DCS MS-016

Docket Nos. 50-266
and 50-301

SAFETY EVALUATION REPORT
INSTRUMENT BUS MODIFICATIONS
POINT BEACH NUCLEAR PLANT, UNITS 1 AND 2

Figure 1

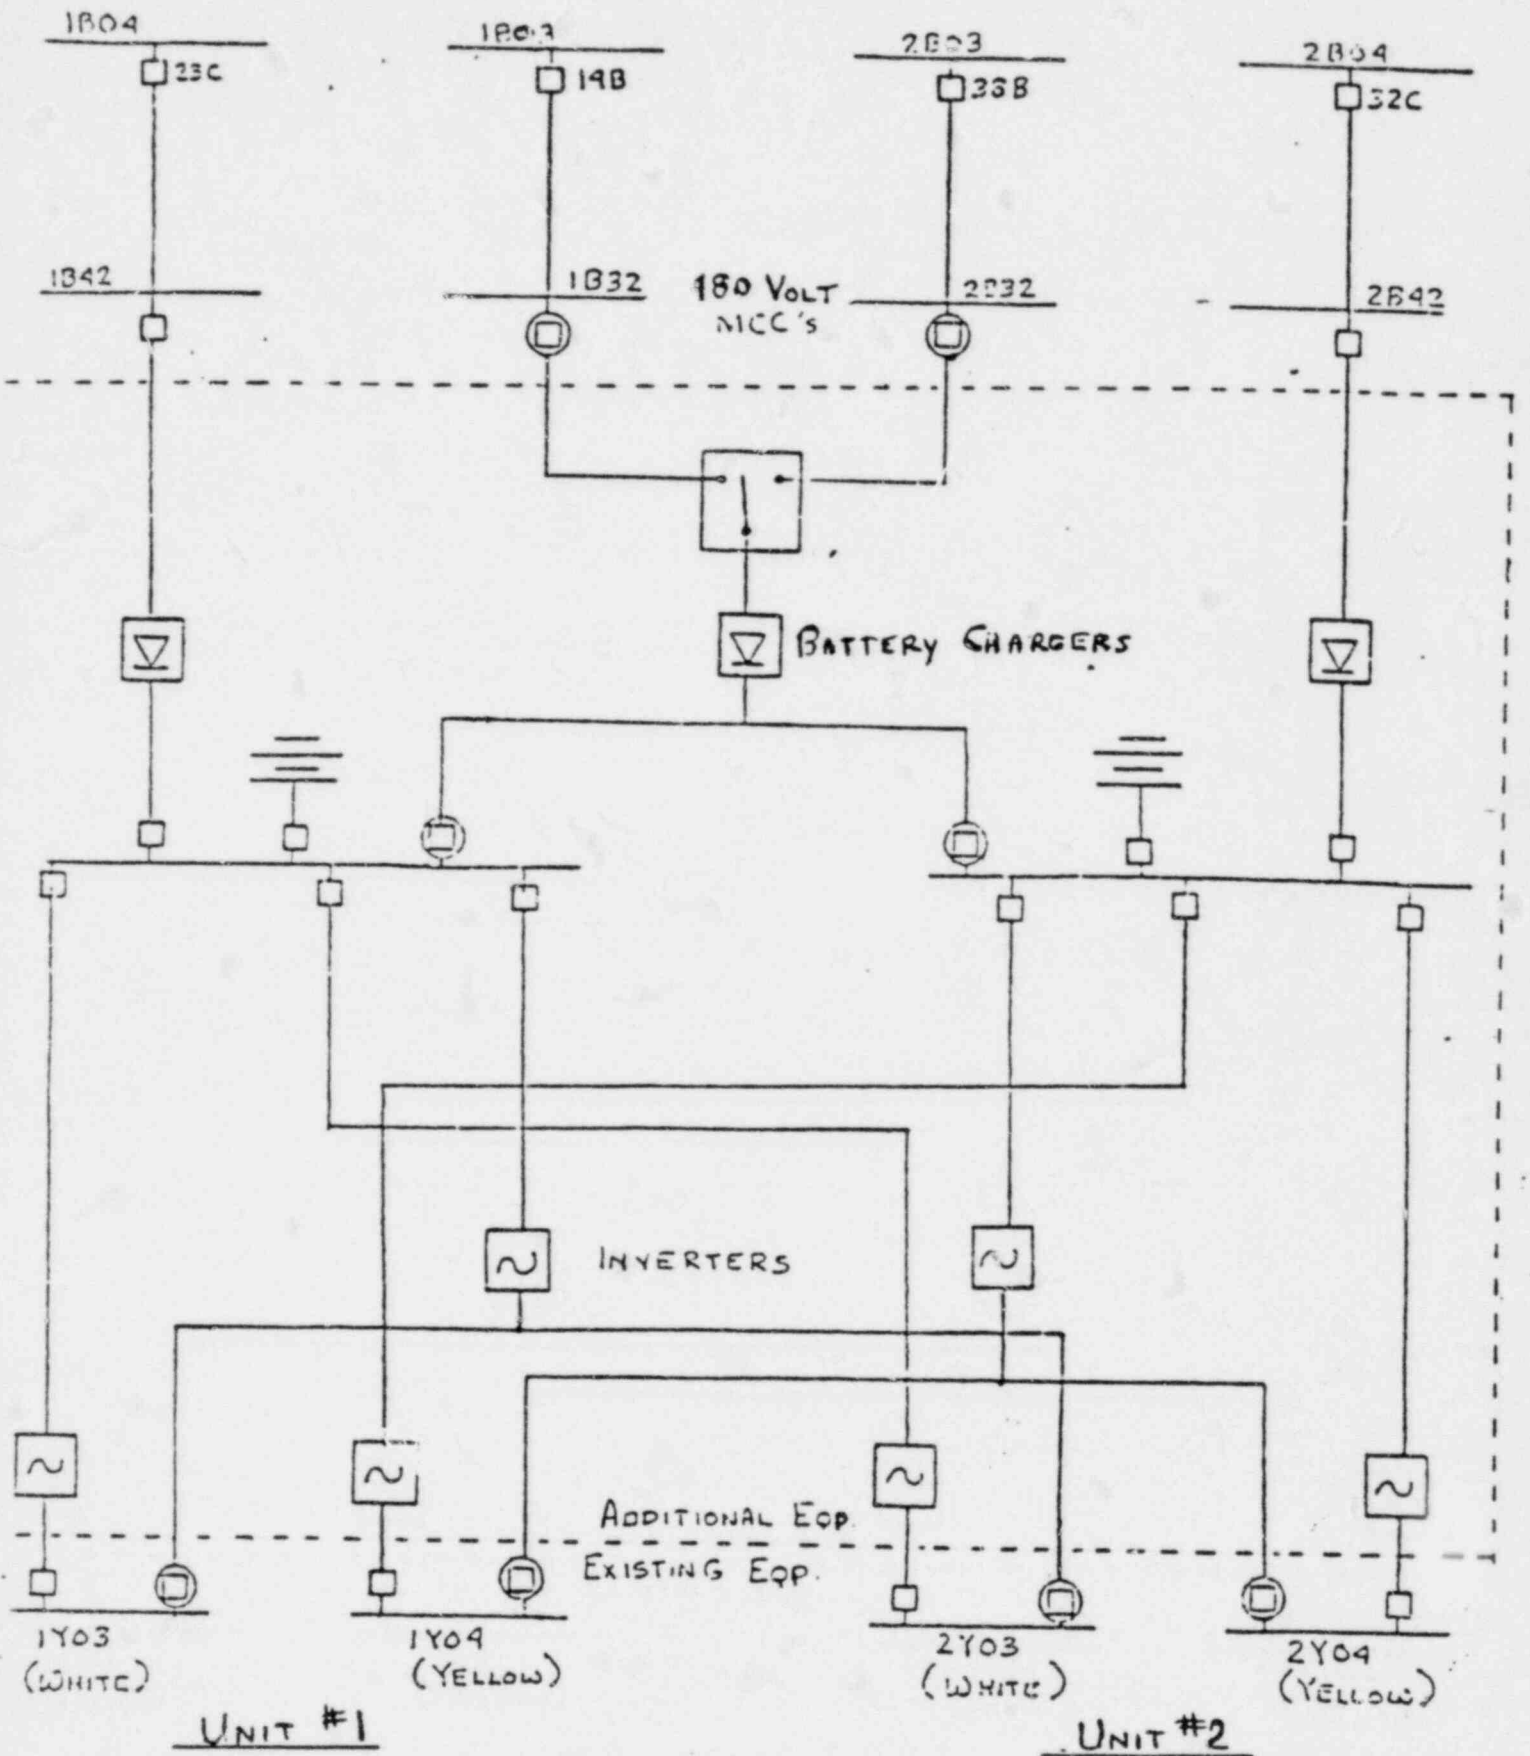
The modification to the instrument bus power supplies consists of the addition of two batteries, three battery chargers, six static inverters, and associated distribution buses and wiring to supply power to the white (1Y03 and 2Y03) and yellow (1Y04 and 2Y04) instrument buses of both units (see Figure 1). These modifications essentially duplicate the existing power supply arrangement for the red (1Y01 and 2Y02) and blue (1Y02 and 2Y02) instrument buses.

Under the proposed design, each instrument bus would be powered by one of two static inverters receiving power from a DC bus. Redundant instrument buses (white and yellow) would be powered from independent and redundant DC buses. The DC buses would each be powered by a battery bank or a battery charger. A third, shared battery charger would be capable of serving either DC bus but would be interlocked to prevent the redundant DC buses from being connected.

The proposed modification in combination with the existing power supply design for the red and blue instrument buses results in an instrument bus system which can be operated without offsite power. The design is such that the worst case single failure in conjunction with a loss of offsite power and a LOCA in one unit, would result in the failure of only one instrument bus per unit. Such failure could not result in a spurious starting of all emergency loads in both units.

Based on the above, the staff concludes that the proposed modifications to the Point Beach Nuclear Plant, Units 1 and 2, instrument bus power supplies result in an instrument bus system which is capable of operation without offsite power. Additionally, the four instrument buses per unit are redundant and independent such that no single failure in conjunction with a loss of offsite power and a LOCA in one unit would result in a spurious starting of all emergency loads in both units. Accordingly, the staff finds the modifications to be acceptable.
